Project	IEEE 802.16 Broadband Wireless Access Working Group < http://ieee802.org/16 >	
Title	Transmission Information of Customized MOB_NBR-ADV	
Date Submitted	2007-07-1505	
Source(s)	Hyunjeong Kang, Jungje Son, Changyoon Oh Samsung Electronics Rakesh Taori Samsung Advanced Institute of Technology	Voice: 82-31-279-5084 E-mail: hyunjeong.kang@samsung.com
Re:	IEEE 802.16j-07/019; Call for technical comments regarding IEEE project 802.16j	
Abstract	This contribution proposes a method to provide the instruction to transmit MOB_NBR-ADV that is composed by RS.	
Purpose	Discussion and adoption in IEEE 802.16j	
Notice	<i>This document does not represent the agreed views of the IEEE 802.16 Working Group or any of its subgroups. It represents only the views of the participants listed in the "Source(s)" field above. It is offered as a basis for discussion. It is not binding on the contributor(s), who reserve(s) the right to add, amend or withdraw material contained herein.</i>

Transmission Information of Customized MOB_NBR-ADV

Figure A— BM BR header format

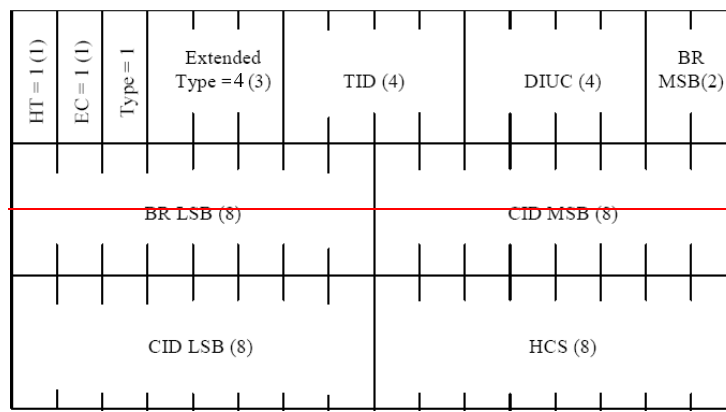
[Insert new subclause 6.3.2.1.2.2.2.5 at line 21 in page 14]

6.3.2.1.2.2.2.5 Broadcast Message bandwidth request header (BM BR)

BM BR header shall be sent by a RS to its MR BS to specify the required bandwidth for the purpose of transmitting broadcast messages over access link that are composed by the RS. The format of this header is illustrated in Figure A and described in Table B.
